STAFF REPORT: FEBRUARY 8, 2023 MEETING

APPLICATION NUMBER: 23-8197

ADDRESS: 15083 MINOCK

SCOPE: DEMOLISH GARAGE*, ERECT GARAGE, DEMOLISH ADDITION, ERECT ADDITION AND DECK, INSTALL VINYL WINDOWS, NEW ENTRY DOOR, GUTTERS/DOWNSPOUTS, LANDSCAPING, WOOD SIDING

July 2022, Google street view

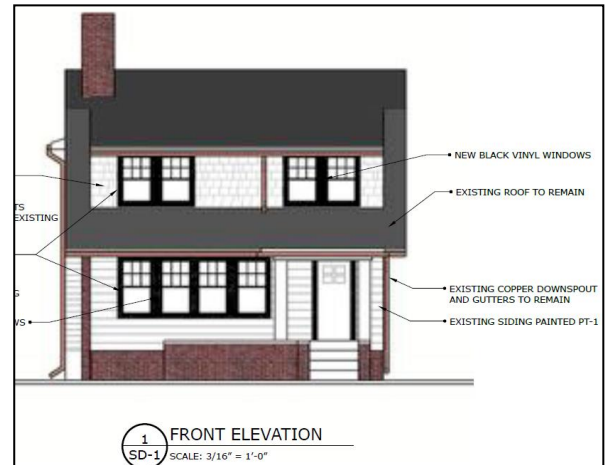
- The following work was completed between August 2018 and July 2021 and shown in the below comparison photographs.
 - A new front door was installed, replacing a non-historic door.
 - Wood shake siding was installed at the front elevation dormer, replacing asphalt siding.
 - Copper gutters and downspouts were installed, replacing white aluminum gutters and downspouts.
 - New front yard landscaping was installed replacing plantings at the base of the front porch.

It is staff's opinion the installation of the front door, wood shake siding, gutters/downspouts and front yard landscaping did not replace historic materials. The installed components are appropriate to the house and site and do not detract from the features and spaces that characterize the property and district. Therefore, staff recommends the Commission issue a Certificate of Appropriateness for the work as installed because it meets the Secretary of the Interior Standards for Rehabilitation and the Elements of Design for the district.

- The wood shake siding will be stained a color approved by staff.

Jeld-Wen V-4500 Vinyl Unit

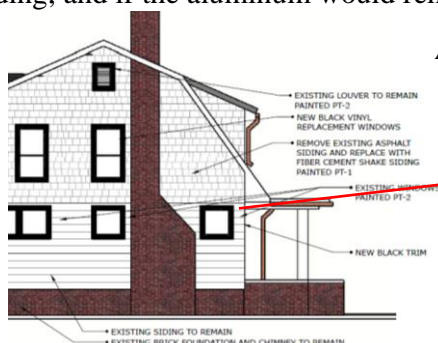
- Staff isn't sure which Jeld-Wen product is currently proposed. The window order that went with the original design (sliding vinyl windows) specifies the "Builder's Vinyl" product, V-2500. This line only offers between-the-glass grids. However, the catalog cut submitted is for Jeld-Wen's V-4500 unit, which offers simulated divided-light muntins. Both vinyl products offer thick sash with little difference between vertical and horizontal components.

Applicant drawing and photos

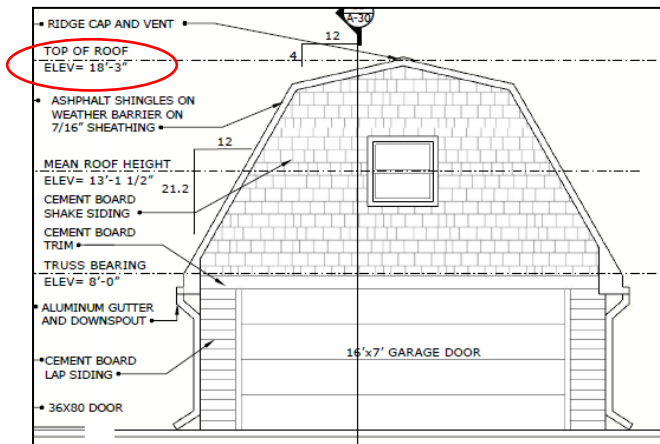
- The proposal states the aluminum siding will be cut back for the installation of vinyl trim/window casings for the remaining first floor wood windows. Not only is there inadequate room at the chimney on the south elevation, staff also isn't clear on the long-term viability of vinyl trim being installed within aluminum siding, and if the aluminum would remain rigid if cut back and terminated against vinyl casings.

Applicant drawings and photo

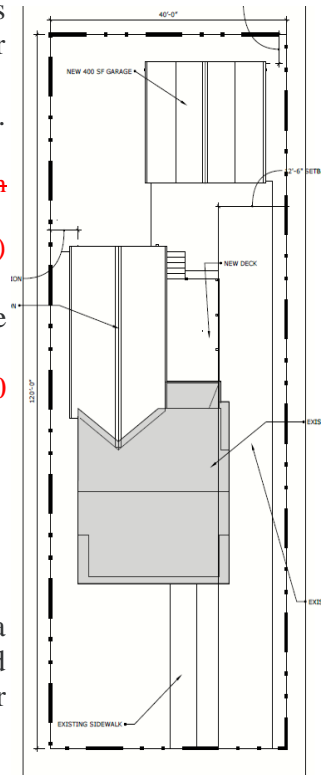
- The addition's southern elevation (shown below) has smaller horizontal windows, which are similar to small windows on the house (which the applicant will retain). It is common for side and rear elevation windows to have one-over-one sash (which are shown on the addition's northern and west elevations).

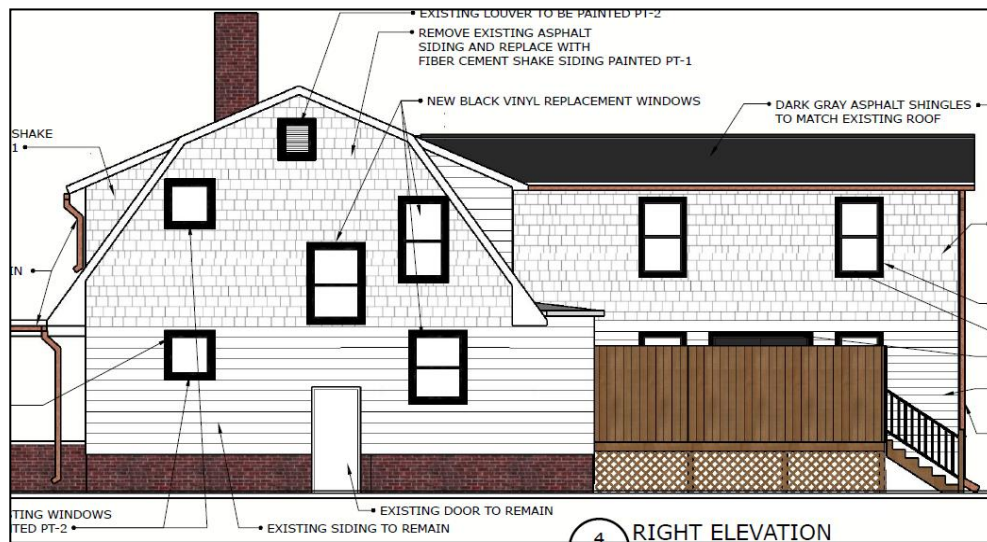
- The term "moderately scaled dwellings" is referenced in multiple elements of design. As staff mentioned with the garage, a two-story addition with a finish

height of ~~over 20'~~ 19'-8" high (~~when the raised foundation is considered~~) and extending 23' ~~almost 29'~~ back from the house, and within five feet of the lot line, will create a large impact on the neighboring house to the south.

- Staff isn't opposed to the erection of an addition or a 20' x 20' garage, rather the main opposition is over the scale of each structure. Additions extending from the rear elevation are very common, however they often have flat or low slope shed roofs starting at/near the house's eave. ~~An addition should also not have a larger footprint than the house (whether in direct length or overall square footage).~~ Just as the width of the proposed addition is about half the width of the house, the addition's length should be at most half of the existing house's length. Therefore, all elevations would be more proportional to the house, lot, and neighboring properties.
